Part No. **27109**

MANUFACTURING SHEET

TILLER HANDLE

CORSAIR MARINE INC.

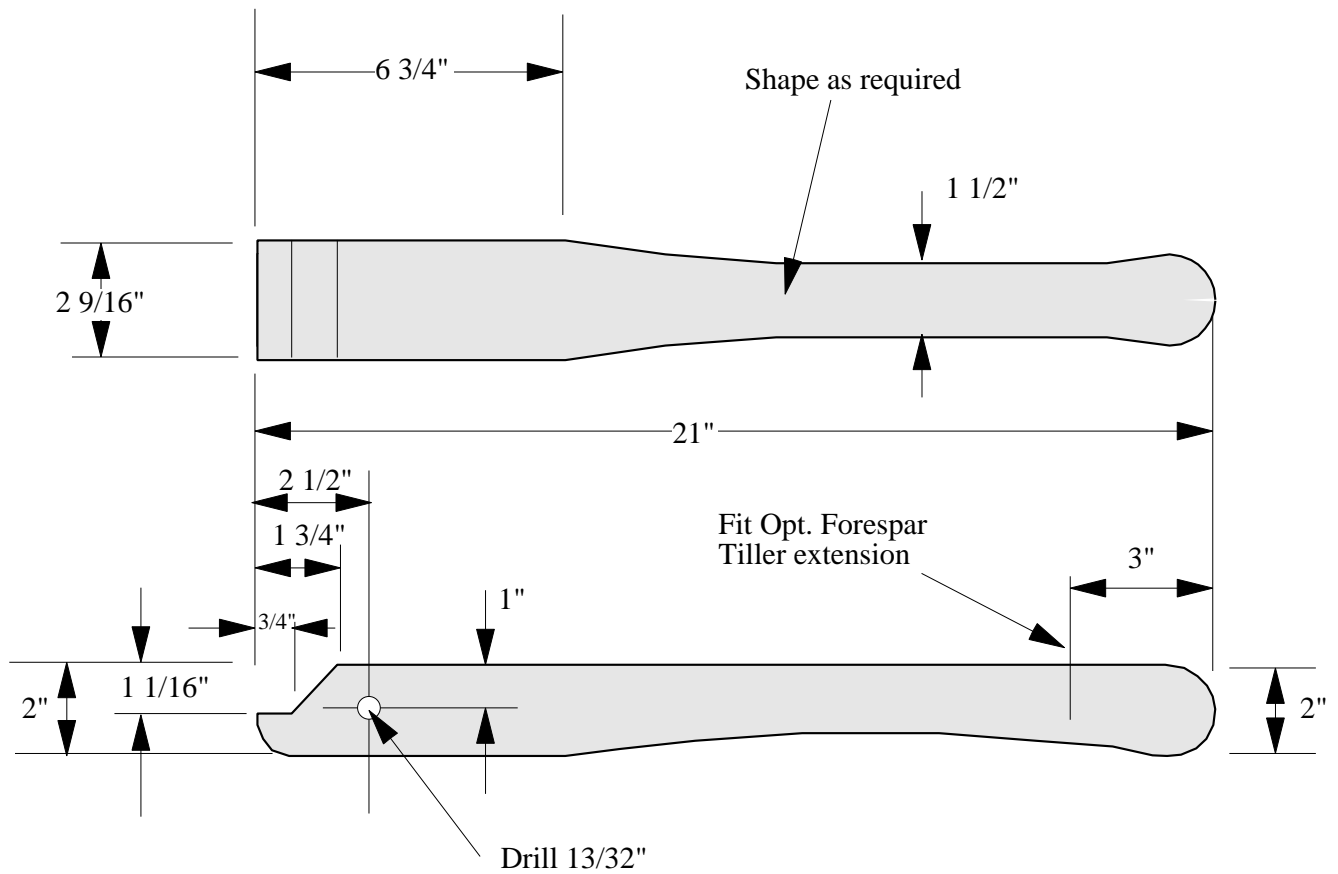
Changes: 6/23/89
Pivot hole increased to $\frac{13}{32}$ " and position changed to suit new tiller
